**STAFF RECOMMENDATION**

**2618 Barton Avenue**

**June 16, 2021**

**Application:** New Construction—Addition; Setback Determination  
**District:** Hillsboro-West End Neighborhood Conservation Zoning Overlay  
**Council District:** 18  
**Base Zoning:** RS7.5  
**Map and Parcel Number:** 10411016300  
**Applicant:** Blaine Bonadies, Architect  
**Project Lead:** Sean Alexander, sean.alexander@nashville.gov

Figure 1: 2618 Barton Avenue

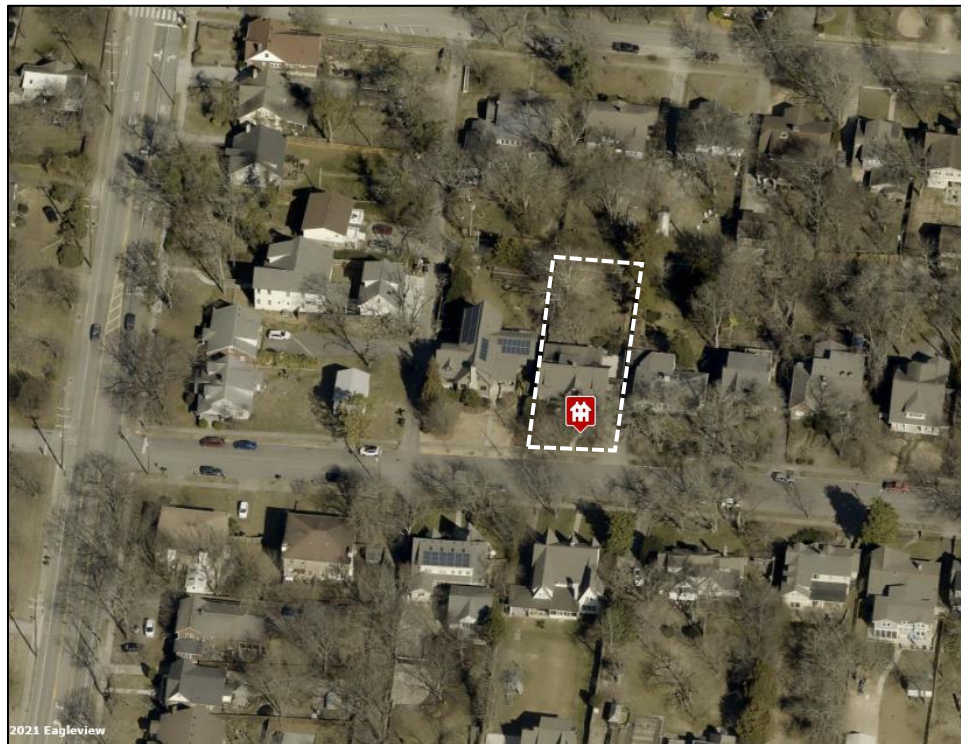
**Background:** The structure at 2618 Barton Avenue is a one and one-half-story house, with Craftsman and Tudor Revival features. The house was constructed circa 1930. The house is contributing to the historic character of the district because of its age and architectural character.

The house is shifted toward the left side of a sixty-foot (6') wide lot, sitting approximately two feet, six inches (2'-6") from the left side property line.

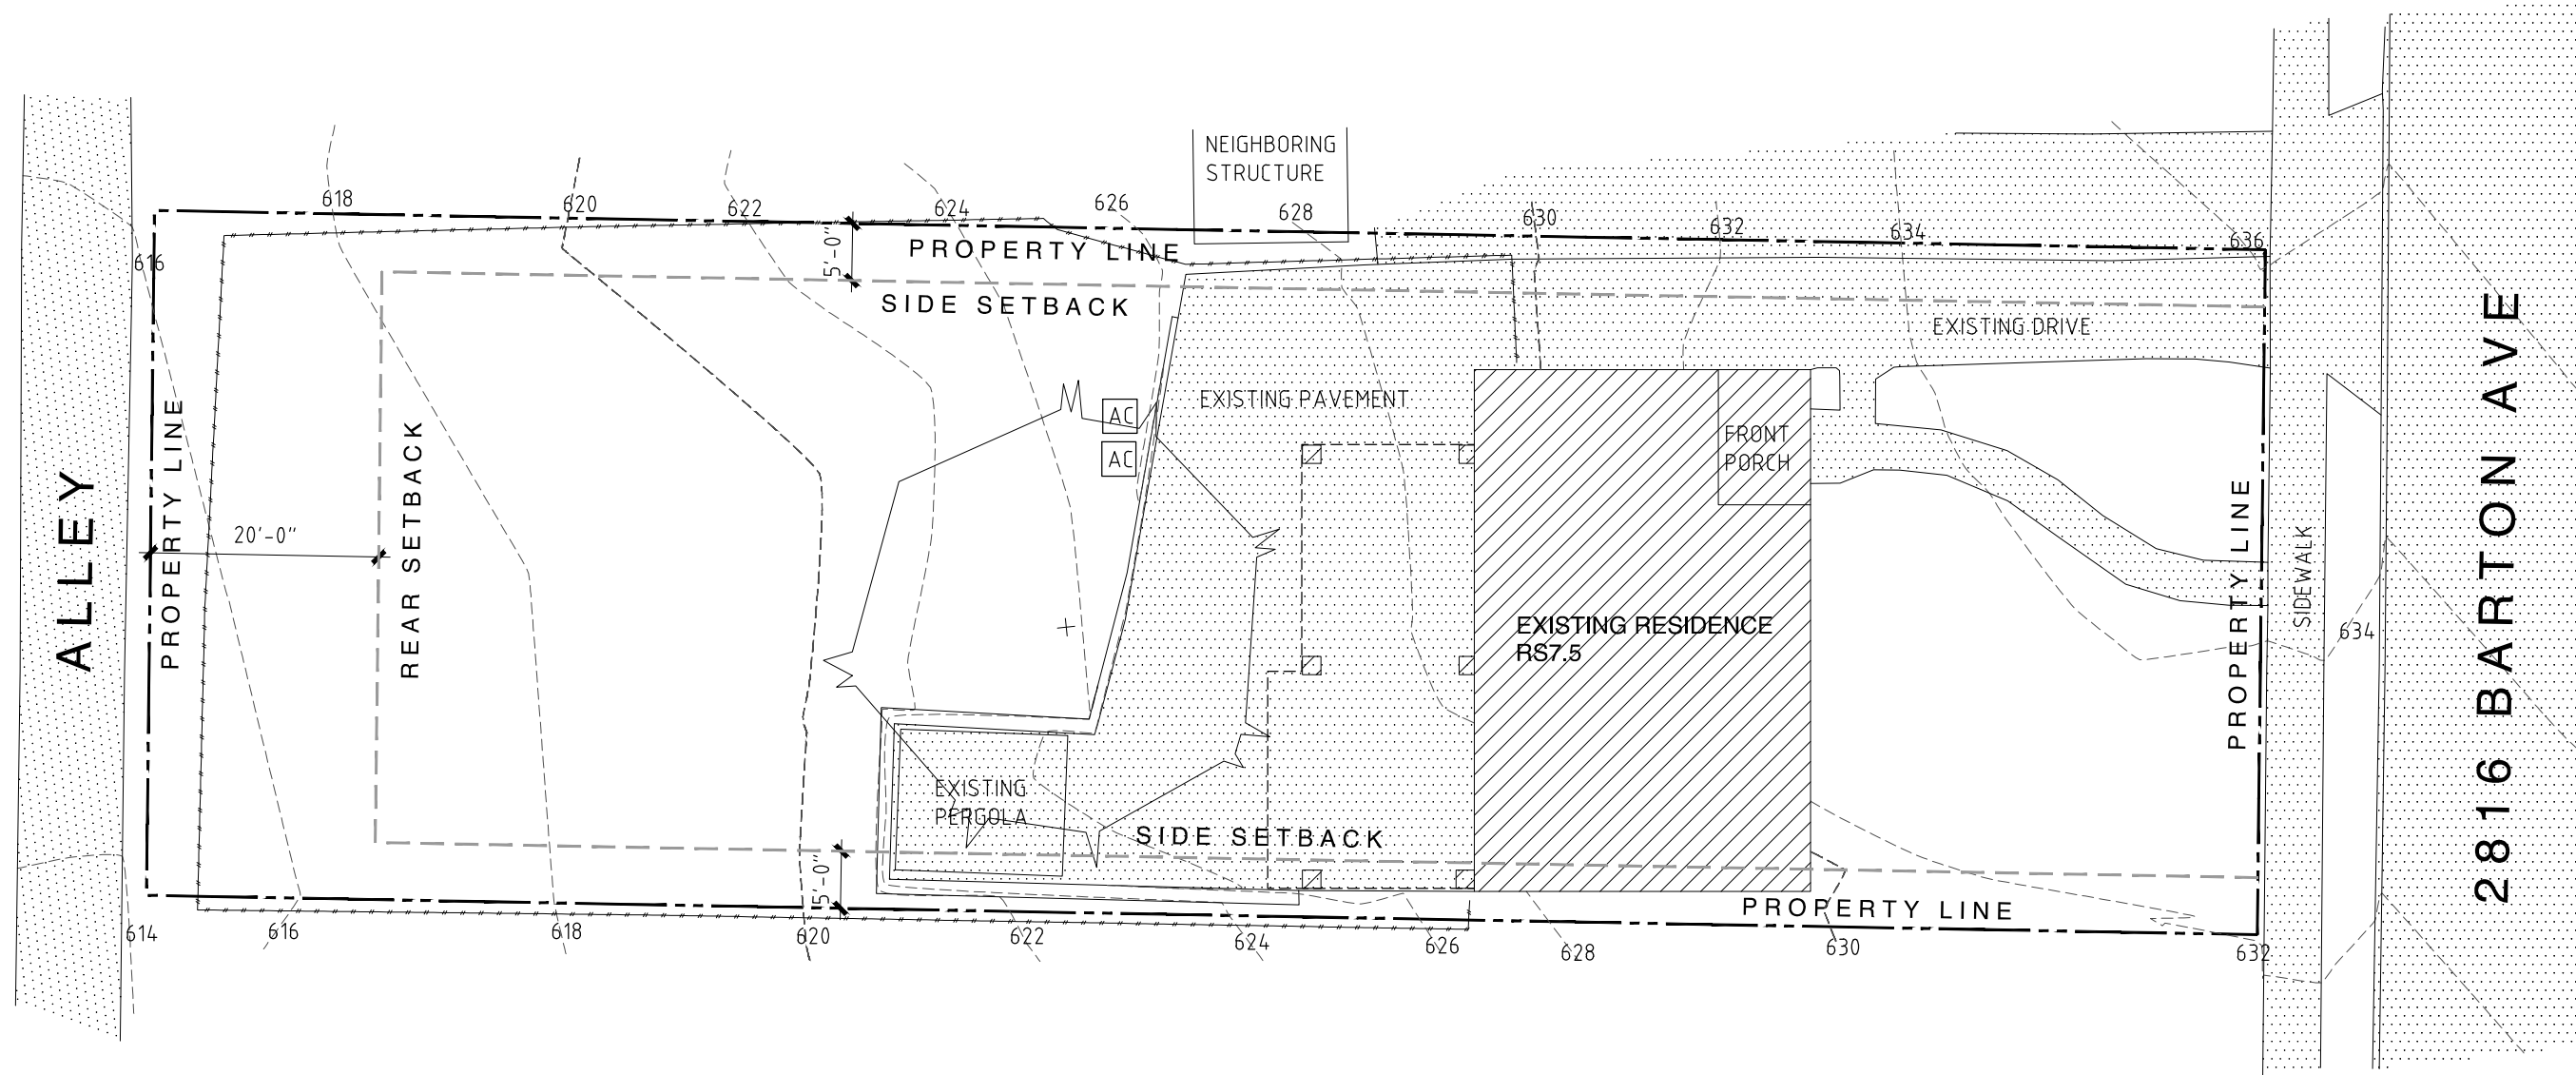
Proportion and Rhythm of Openings: The windows on the sides of the proposed addition will be consistent with the pattern and proportions of windows on the historic house.

Staff finds the project's proportion and rhythm of openings is compatible with the historic house, meeting Section II.B.1.g. of the design guidelines.
